MANDATORY SERVICE BULLETIN

NUMBER: SB-012 **AMENDMENT 1**

SUBJECT: FUEL SYSTEM; MANDATORY INSPECTION (WING) **AMENDMENT 1**

Figure 1: Fuel Tank Outlet Port

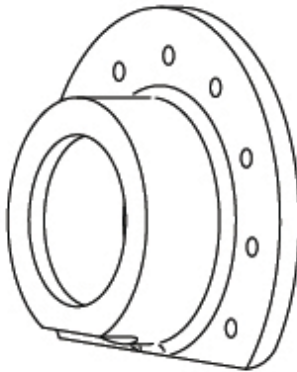
Quest is requiring a one-time inspection of the wing fuel tank outlet port connections. The inspection will consist of ensuring Pro-Seal fuel sealant is present on the threads of the fuel tank outlet port (P/N 100-828-4405).

Inspect the wing fuel tank outlet port connections as prescribed in the instructions attached.

The inspection portions of is Mandatory Service Bulletin must be completed no later than next scheduled maintenance interval, if no leaks are noted then repairs can be deferred to next annual service.
